SUBJECT: DUANE ARNOLD ENERGY CENTER - ISSUANCE OF AMENDMENT
REGARDING ALTERNATIVE SOURCE TERM (TAC NO. MB0347)

Amendment No. 240
License No. DPR-49

SAFETY EVALUATION BY THE OFFICE OF NUCLEAR REACTOR REGULATION
RELATED TO AMENDMENT NO. 240 TO FACILITY OPERATING LICENSE NO. DPR-49
NUCLEAR MANAGEMENT COMPANY, LLC
DUANE ARNOLD ENERGY CENTER
DOCKET NO. 50-331

Figure 1
LOCA Model

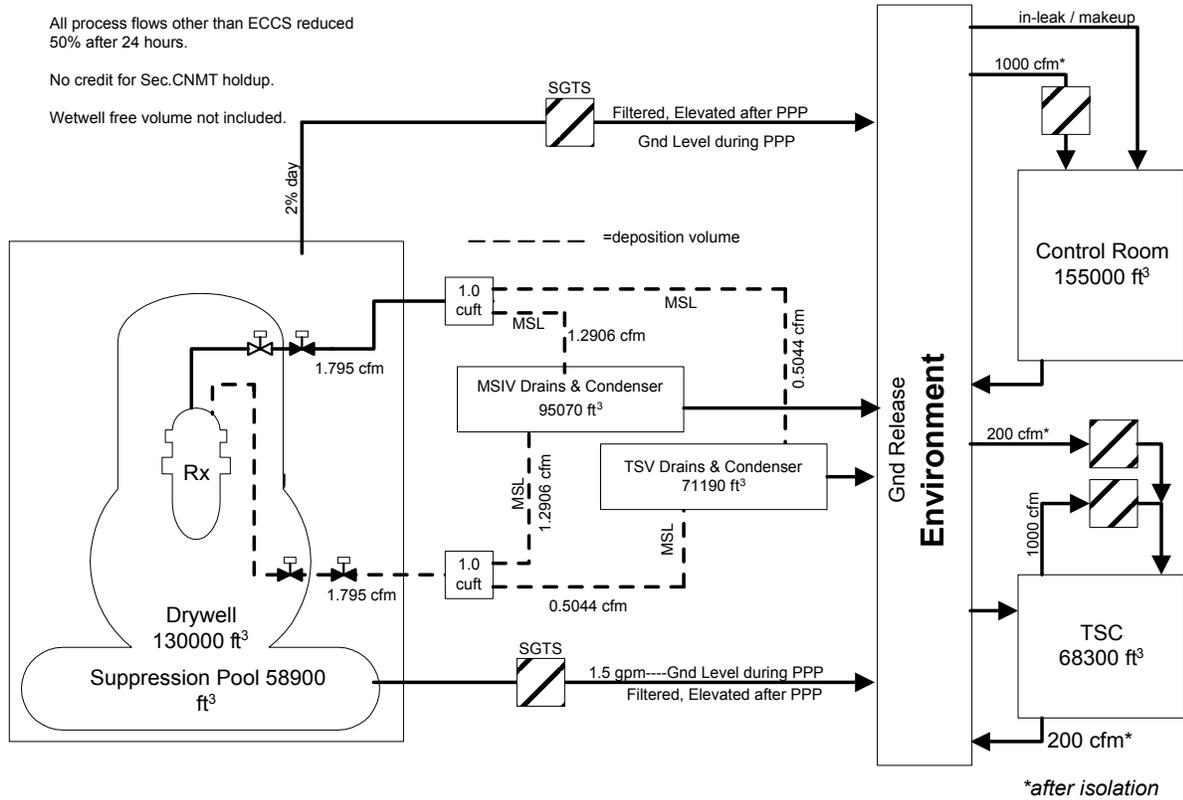
Based on this review, the staff concluded that the licensee's application of the AST to the DAEC LOCA analysis is acceptable. Figure 1 illustrates the model used by the staff. Table 1 provides the analysis assumptions found acceptable by the staff. Table 2 provides the doses projected by NMC.
